SUMMARY OF: P820003/S117 AND P890003/S265

SYNERGYST II/VERSATRAX PACING REUSABLE SURGICAL CABLES MEDTRONIC, INC.

EXECUTIVE SUMMARY/BACKGROUND

Figure 2. Proposed Solderless Alligator Clips on 2292 Cable

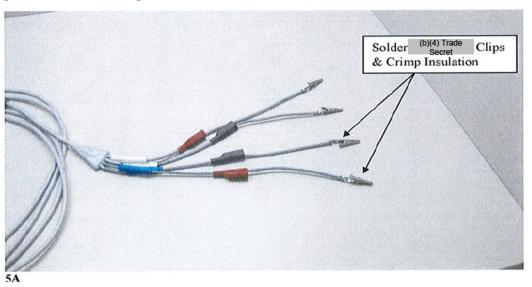
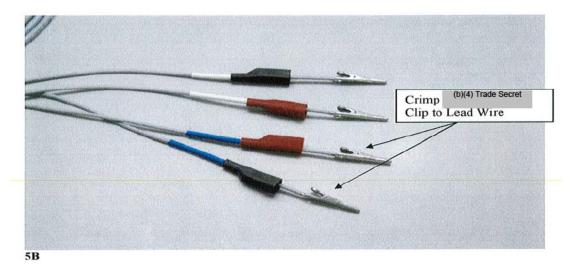
Figures 1 and 2 show the differences on cable 2292 and further details were provided interactively to elucidate the design change. However, the figures below illustrate that all 4 of the 2292 IS1 clips will be replaced with 4 IS4 clips and the 2 5832S IS1 clips will be replaced with 2 IS4 clips.

In your submission you indicate that you would like to incorporate DF-4 compatible alligator clips onto the 2292 and 5832S reusable cables. It is unclear how you have determined that the specific clips chosen are compatible with DF-4 leads.

- a. Please provide a description of the design elements and/or associated testing on the proposed alligator clips that demonstrate DF-4 compatibility.
- b. Please also provide a description of how the clips will be used with the DF-4 leads; in particular, please indicate whether they are intended to be clipped directly to the lead or to an adapter that attaches to the lead connector terminal.
 - i. If they are intended to clip directly to the lead, please provide your assessment of the risks of (1) mechanical damage to the lead connector terminals and (2) risk of shorting between terminals when the clips are attached, including a discussion of any mitigations to those risks.

In response to question 1a, the firm states that both design and testing elements support the proposed IS4/DF4 compatibility. A curved section on both the upper and lower jaws allows smooth contact with the ACI. The jaws also include small teeth at the front to enhance connecting to the smaller diameters of lead pins and wires. Compatibility testing for the IS4/DF4 leads was completed and included in this submission. Grip retention on various diameters encompassing the range associated with both IS1/DF1 leads and Medtronic IS4/DF4 ACI products was completed. Clip life cycle, dimensions, and workmanship testing were also completed.

For question 1b, the firm states that the alligator clips are intended to be clipped to an adapter that attaches to the proximal end of an IS4/DF4 lead. An ACI adapter is provided with every Medtronic IS4/DF4 lead and the design includes physical barriers to prevent the alligator clips from touching: each other, multiple conductive rings or the essential insulation between the conductive rings on the lead. The alligator clips are physically prevented from shorting to each other and the lead insulation sections cannot be scratched by the clips.

It appears that the firm has conducted the necessary testing to show compatibility with both IS1/DF1 and IS4/DF4 leads. I spoke with the division's lead expert, who agreed that the grip retention and clip life cycle testing mitigate the risks associated with the clip change. As long as the same ACI adapters are in use with the new clips, there are no increased risks of the clips causing damage or shorting. I have no further concerns with this interactive deficiency.
